SUBDIVISION COMMITTEE
METROPOLITAN AREA PLANNING COMMISSION

STAFF REPORT
(Preliminary Plat)

CASE NUMBER: S/D 94-54 WOODLAND HILLS ADDITION

STAFF REPORT
(Final Plat, Preliminary Plat Approved 1/5/95)

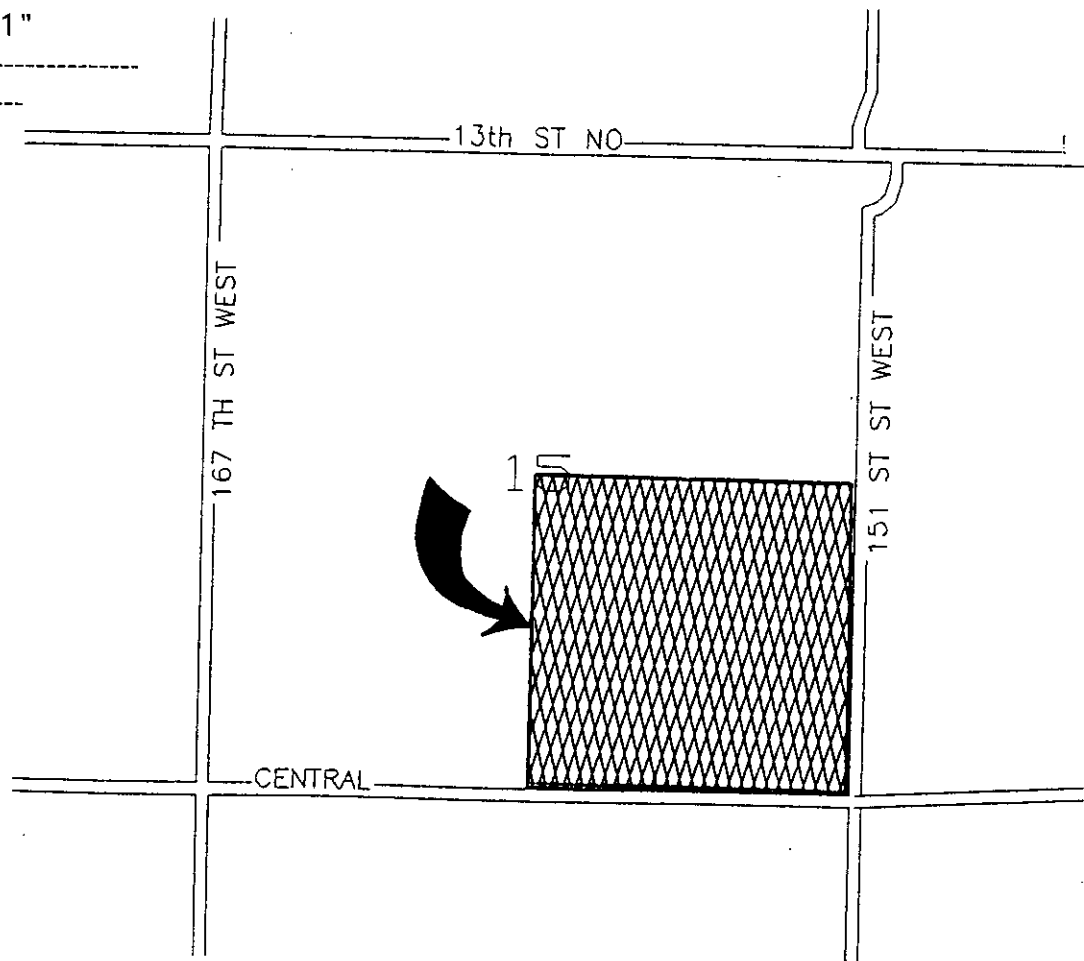
- A. Since neither municipal water nor sanitary sewer is available to serve this property, the applicant shall contact the Environmental Health Division of the Health Department to find out what tests may be necessary and what standards are to be met for approval of on-site sewerage facilities and water wells. A memorandum shall be obtained specifying approval.

- B. The applicant shall guarantee the installation of interior streets to the suburban, gravel standard. This guarantee shall also provide for temporary cul-de-sacs for the termination of the two street segments at the Northwest corner of this plat. These turnarounds if on-site, need to be shown on the plat and shall also be referenced in the plat's text, particular noting the conditions(s) under which the turnarounds are automatically vacated. If off-site, dedications by separate instrument shall be provided, for such turnarounds.

- C. The applicant shall guarantee any drainage improvements required by the platting of this property.
- D. On the final plat, access control shall be dedicated from the lots adjacent to Central and/or 151st Street West. Only those lots without other access to an interior street shall indicate access to these streets and then no more than 1-opening from a lot shall be indicated to these streets. Lot 9, Block A shall also provide the standard complete access control at the intersection of Central and 151st Street West.

- E. The representative from the County Fire Department should be prepared to indicate if at least temporary emergency access needs to be provided for a portion of this site. Lots in the Northwest corner of this plat will be served by a single means of access until such time as adjacent property plats and connects to the streets shown on this plat. These lots will be nearly 1/2 mile from the site's entrances off of Central. However, this is a low-density development with lots at or greater than five (5) acres in size and in an emergency, vehicles could potentially drive around obstructions with lots this size. If emergency access is considered necessary, the final plat needs to show a sufficient easement for such access and a means of assuring the installation of an appropriate driving surface shall be provided.

- F. While the Subdivision Regulations encourage or supports the placing of pipelines and their easements into areas platted as Reserves (i.e., not as part of a lot), it would not appear that this plat involves a situation that warrants such an action. No homeowners association is expected

for this Addition, densities are quite low, as shown the Reserves would create unacceptable divisions of two lots (Lot 1 and 2) and only the owners of Lots 1, 2, and 8 are involved with the pipeline as it crosses this site. Consequently, it would be appropriate to allow the pipeline to be shown within its easement and therefore as part of the lots and not a separate Reserve or set of Reserves.

As indicated on the preliminary plat, the pipeline is now a blanket easement and will be confined as shown. However, this must occur before the plat can be released for recording, with the easement property labeled, recording information shown and any building setbacks from the pipeline also shown. A copy of the easement shall be submitted to Planning. It is the applicant's agent's responsibility to determine and properly depict such information.

- G. Any relocation, lowering or encasement of the pipeline, made necessary by this development, will not be at the expense of the County.
- H. On the final plat, appropriate street names shall be indicated. As possible, existing names shall be used. For the north-south street, Reece Road is a possibility and for the east-west street (both segments), Kenny, Hickory or Birch are possibilities. The County Fire Department representative should indicate any preferences.

- I. The final plat shall depict any requirements for drainage easements, reserves, etc. Also, although no FEMA floodway appears to impact the site, a 100-year floodplain is indicated in the northcentral portion of the site. County Engineering needs to therefore, indicate any requirements for minimum building pad elevations.

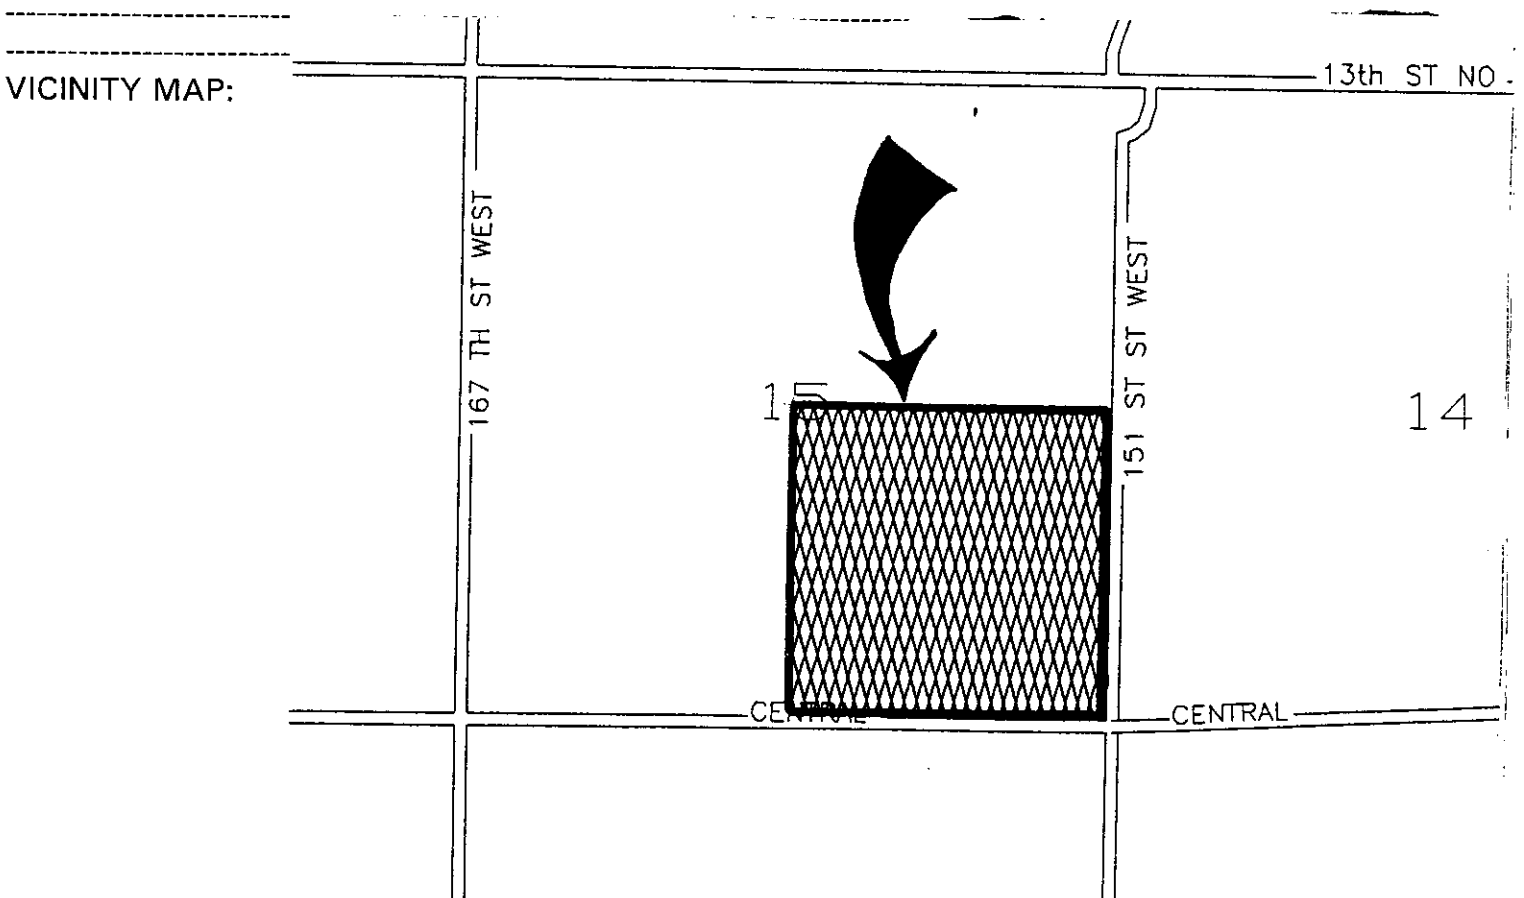
- A. Since neither municipal water nor sanitary sewer is available to serve this property, the applicant shall contact the Environmental Health Division of the Health Department to find out what tests may be necessary and what standards are to be met for approval of on-site sewerage facilities and water wells. More information is required concerning floodplain boundaries. A memorandum shall be obtained specifying approval.

- B. The applicant shall guarantee the installation of interior streets to the suburban, gravel standard. This guarantee shall also provide for temporary cul-de-sacs for the termination of the two street segments at the Northwest corner of this plat.

- C. The applicant shall guarantee any drainage improvements required by the platting of this property.
- D. As indicated on the preliminary plat, a pipeline existed on this site as a blanket easement and needs to be confined before the plat can be released for recording. The recording information and any building setbacks from the pipeline shall be shown on the final plat tracing. A copy of the easement shall be submitted to Planning. It is the applicant's agent's responsibility to determine and properly depict such information.

- L. During review of the preliminary plat, it was indicated that because of the length of Reece and its present status as a "one-point of entry" type street, that a means of emergency access could or would be provided to this street, from 151st Street West, across more or less the northern portion of the plat. The representative from the County Fire Department needs to indicate if such access, at least as a temporary use, needs to be provided. The applicant should be prepared to indicate where such access could potentially be provided; e.g., along the north line of the plat, from the terminus of Hickory Circle west or northwestward to Reece, and so forth.

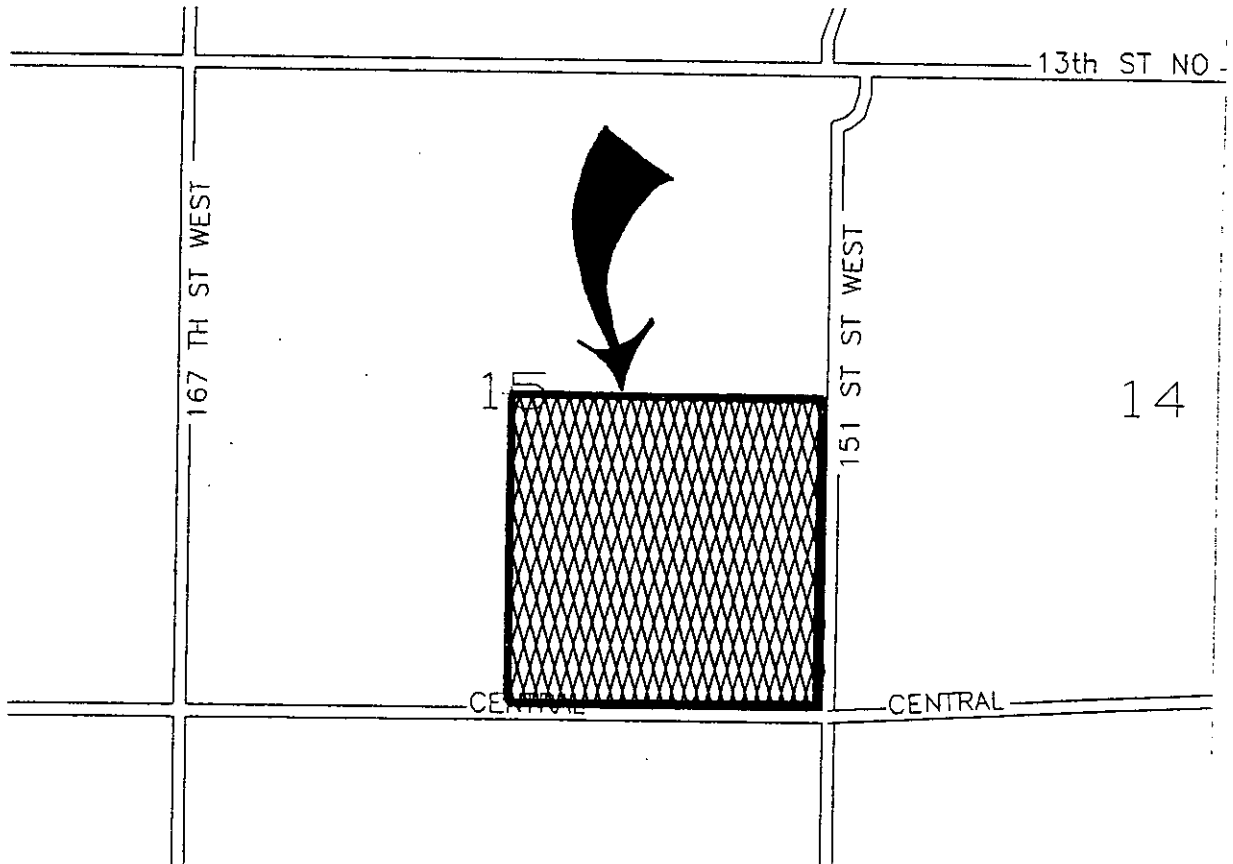
As indicated by the attached letter, the Planning Department has not approved the reference plat and consequently is not authorizing submittal of a preliminary plat. It should be noted that while the applicant had submitted a preliminary plat without first providing a sketch plat, the for going of the sketch plat is at the discretion of the Planning Department and not the applicant. Consequently, Planning has treated this plat as a sketch rather than a preliminary plat. As is also noted in the attached letter, the applicant may appeal the Planning Department's decision to the Subdivision Committee. At this point, the applicant's appeal is only in terms of being allowed to have the plat reviewed as a sketch.

The following comments pertain to the large lot preliminary plat "Woodland Hills Addition" located at 151st Street west and Central you recently submitted for review. Staff has concerns with this proposed development as the west half of the proposed plat is located in an area designated by the Wichita-Sedgwick County Comprehensive Plan's "Sedgwick County Development Guide" as "agricultural." The east half is designated as "urban reserve." By definition, "The agricultural category has the intent of protecting agricultural resources and is meant to accommodate agricultural operations on substantial acreage. Subdivision into multiple lots less than 20 acres in size generally should be developed through cluster provision that reserve land for agricultural or open space..." The "urban reserve" area is an area "...where urban development due to the expansion of Wichita is likely to occur by 2010...but the land does not appear to be necessary for development within the next ten years. Until urban density development occurs, only typical rural densities would be encouraged in these areas."

In staff's opinion, the proposed plat is not consistent with these recommendations. As proposed, the development pattern is suburban in character in an area which the plan specifically states is inappropriate. Following the plan's recommendations, staff would recommend a couple of options:

Although this plat was submitted as a preliminary, staff would have preferred it be submitted as a sketch, and will treat the plat as a sketch. If the applicant wants to proceed with the current proposal, staff recommends that the applicant appeal to the Subdivision Committee for a ruling on staff's interpretation that the proposal is inconsistent with the Comprehensive Plan. As it stands now, staff would recommend denial of the plat based on comprehensive plan guidelines referenced above; and Subdivision Regulation Article 7, 7-102 which states "A subdivision shall not conflict with the comprehensive plan of the metropolitan area."
